TRANSMISSION**722.901**

To improve fluid supply to the transmission, the transmission oil pan and the overflow tube have been redesigned.

P27.10-2139-06

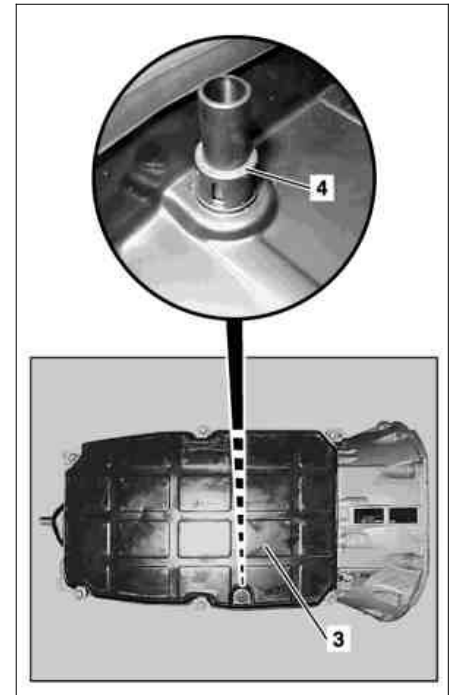
The characteristic sloped surface (arrow) can be used to identify the new oil pan (1). This oil pan configuration should be installed only together with the white overflow tube (2).

The fluid temperatures used as references for checking and refilling are different with the new components.

Whenever a transmission is removed for repairs, the earlier oil pan (3) with the black overflow tube (4) should be replaced by the new sloped-surface version (1) with the white overflow tube (2).
